**Planning Application SU15/0166**

Land at School Lane, Chertsey Road,  
Windlesham

Analysis Design Guidance / Chertsey Road  
Narrowing Feature

Figure 7.1 Illustrates what various carriageway widths can accommodate. They are not necessarily recommendations.

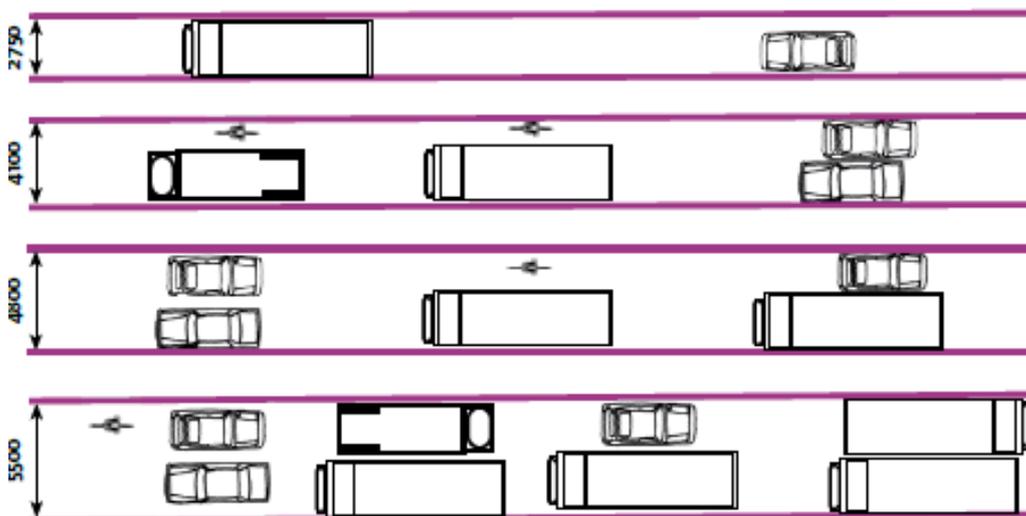
The narrowed width reduces the carriageway by 0.62m from 6.12m to 5.5m. Manual for Streets 1 produced by the Department for Transport (extract attached) indicates that a 5.5m carriageway width is able to accommodate the passing of two HGV's.

Given the guidance in Manual for Streets, a width of 5.5m is the absolute minimum that we would recommend in this instance. The typical sizes of a range of vehicles are attached giving their full dimensions, however their widths are summarised as:

Given these dimensions and the advice contained within Manual for Streets, HGVs, buses and coaches may need to take extra care when passing one another, but all other vehicles will be able to pass each other freely.
